AGENDA ITEM #13

Consideration of Resolution 2021-29 approving a Commercial Conditional Use Permit and Site Plan for ATM Investments to own and operate an American Burger Drive-thru Restaurant located at 307 East Main Street in the CD zone.

To Kristy Clark, Grantsville City Planning and Zoning Administrator
From Shay Stark, Contract City Planner
Date April 27, 2021 Updated May 6, 2021
CC
Subject American Burgers - Site Plan – 3rd Review

DRC NOTES FOR AMERICAN BURGERS – GARY PINKHAM – PLANNING & ZONING

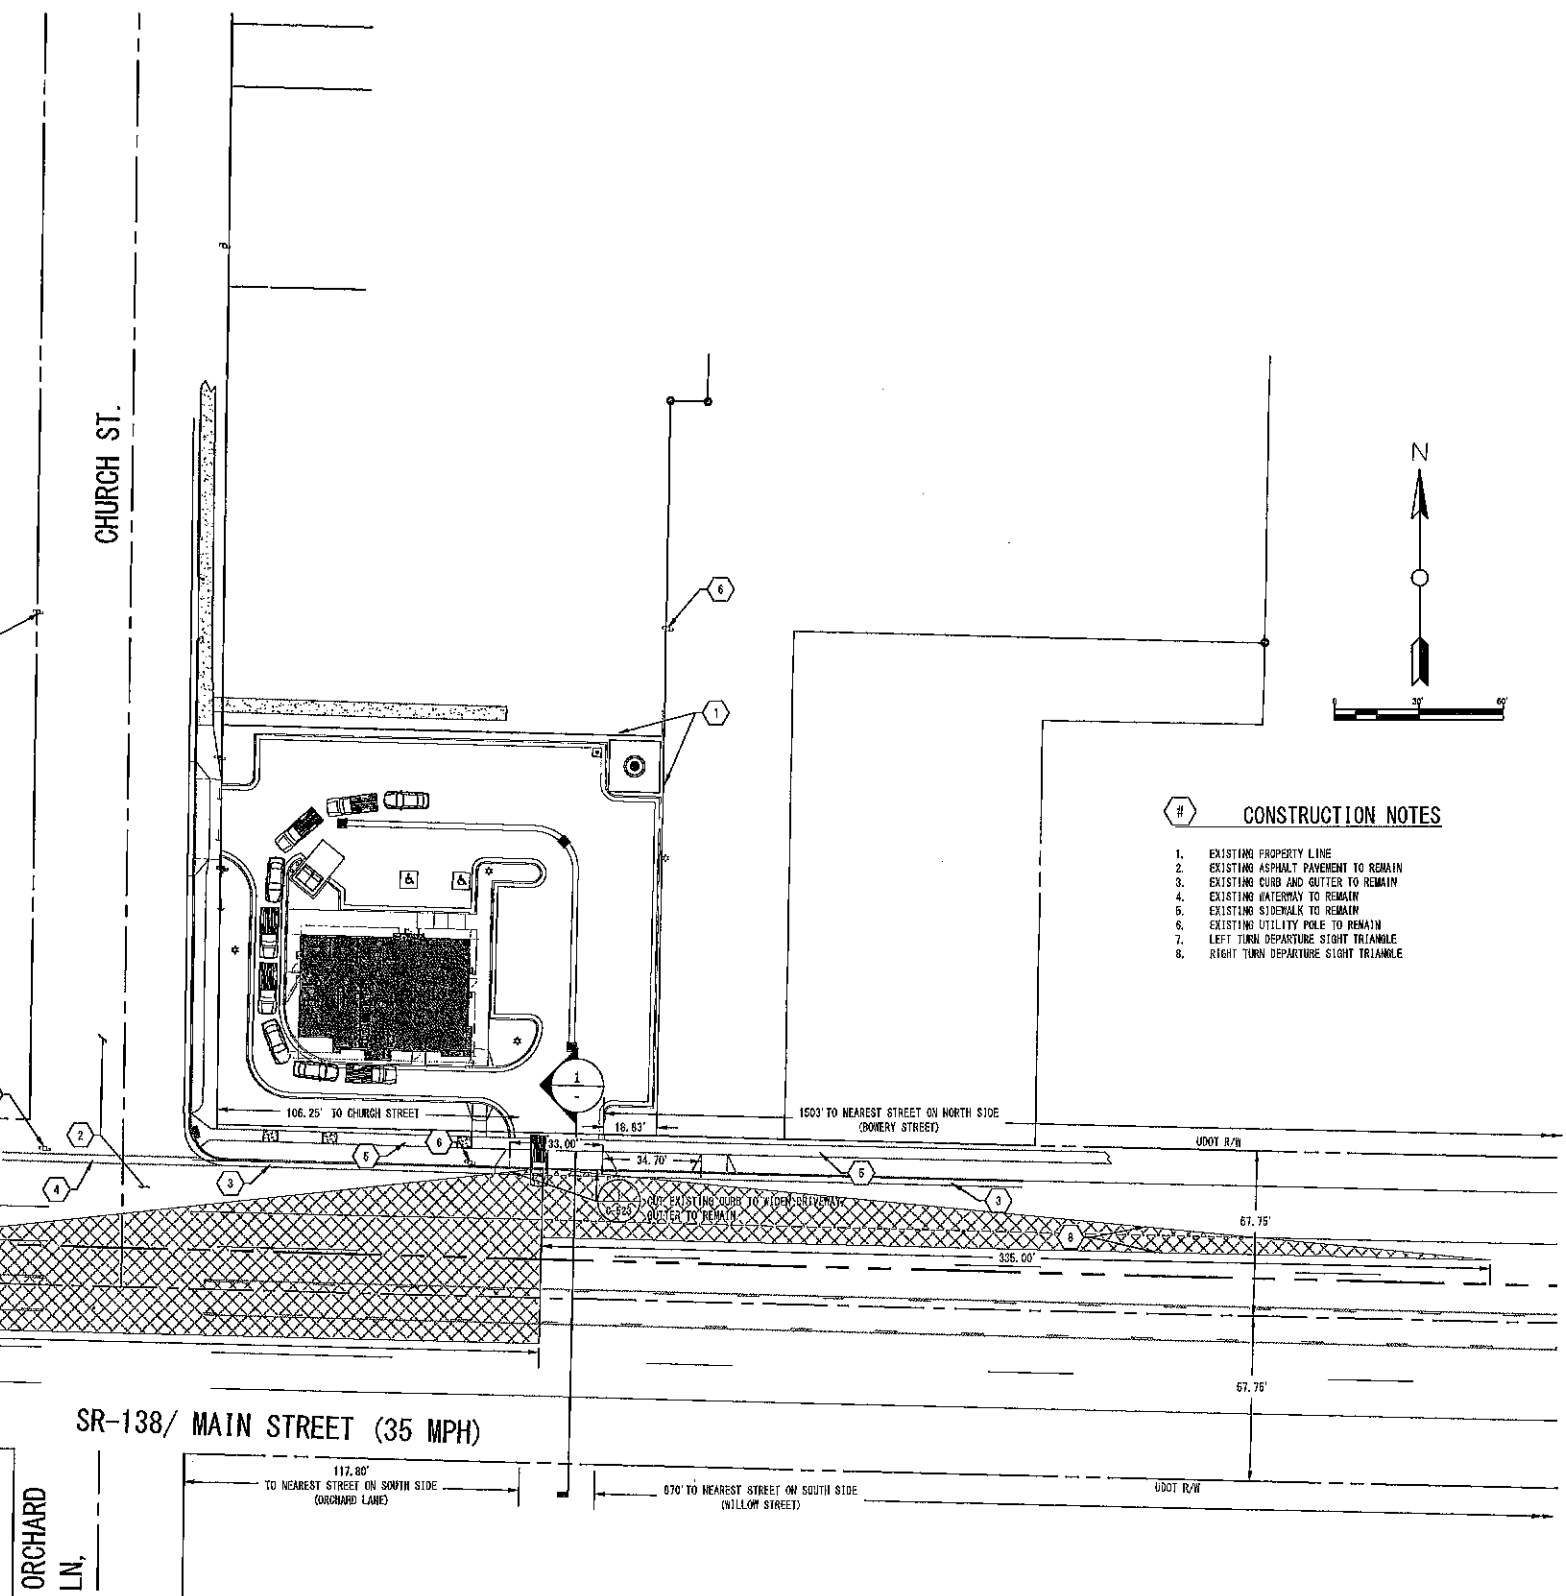
Sheet CS-101 – There are two small areas on either side of the West driveway on the sidewalk. They are not identified. Are these tactile sections to warn pedestrians of the driveway? These areas are just tapered portions of the sidewalk so that the driveway approach slopes are more traverseable. No tactile strips are required for non stop controlled crossings. The driveway flares for the UDOT detail show a 4' width. The reviewed plans show a 5' flare. Per UDOT we widened the width of the driveway to 30' from edge of asphalt (EA) to EA. That makes the total width 33' face to face of curb. If you look at those same drives on Main Street Tooele you will see they are completely inadequate. Should we require something a little wider? We need to meet UDOT standards for the access permit. Is the distance between the curb and the East fence sufficient to prevent the car bumpers from hitting the fence? Land Use Ordinance 6.7 requires 57' 7" wall to wall width providing 2' 6" overhang allowance. So the stalls drawn meet the ordinance. The fence is show for buffering for the neighbors. The owner and neighbors would prefer the fence.

B LANDSCAPE PLAN
SCALE: 1"=20'-0" NORTH

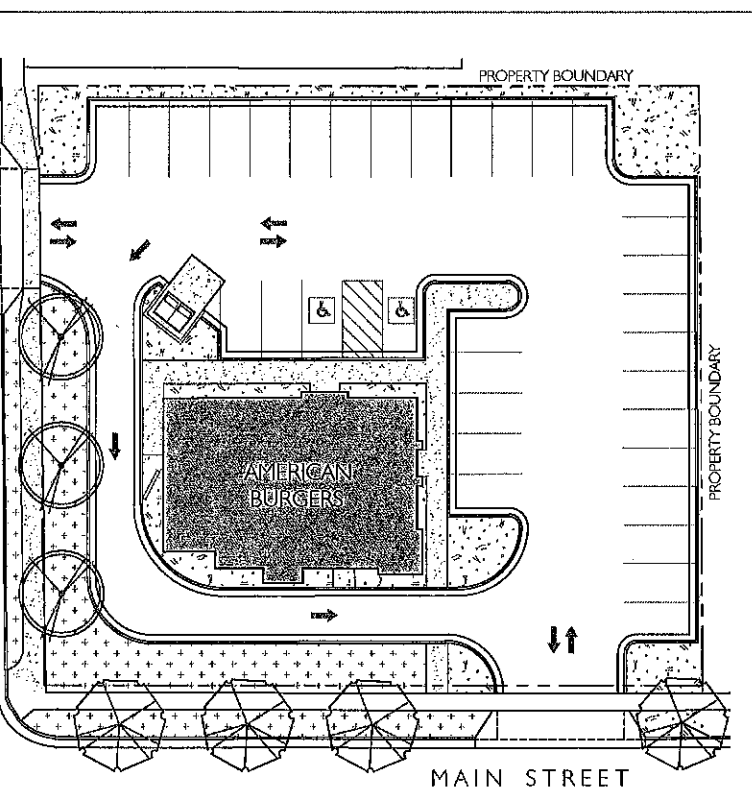
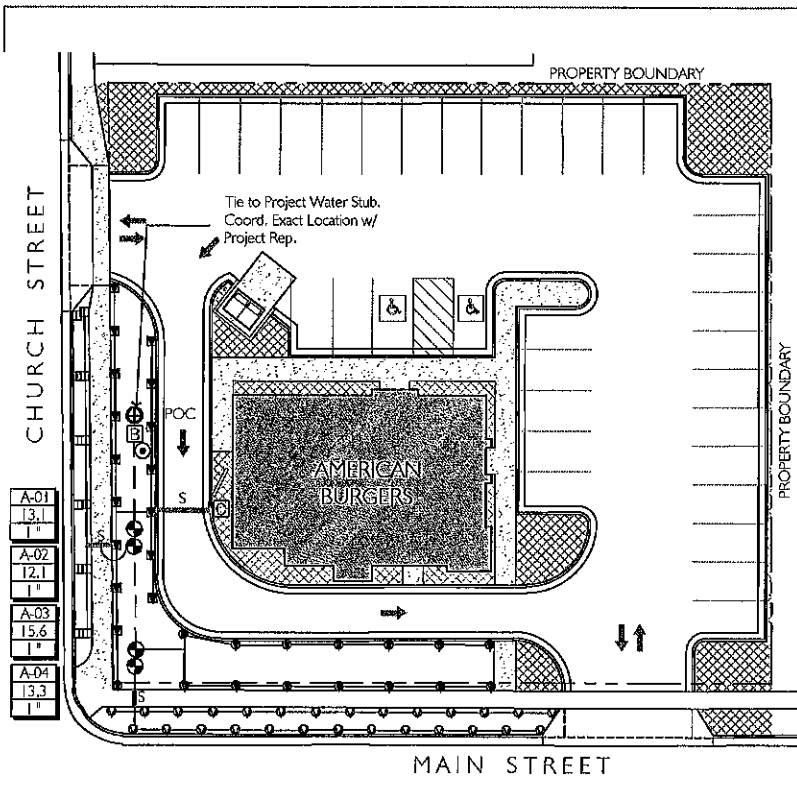
- How is the mulch going to be maintained in the north east corner where the stormwater basin is located? Recommend another material such as rock on the basin sides and bottom so the well does not get filled up with mulch. [The mulch shown is rock mulch.](#)
- What is being recommended for the Landscaping in the Church Street park strip? [This area is shown as grass on the landscape plan.](#)
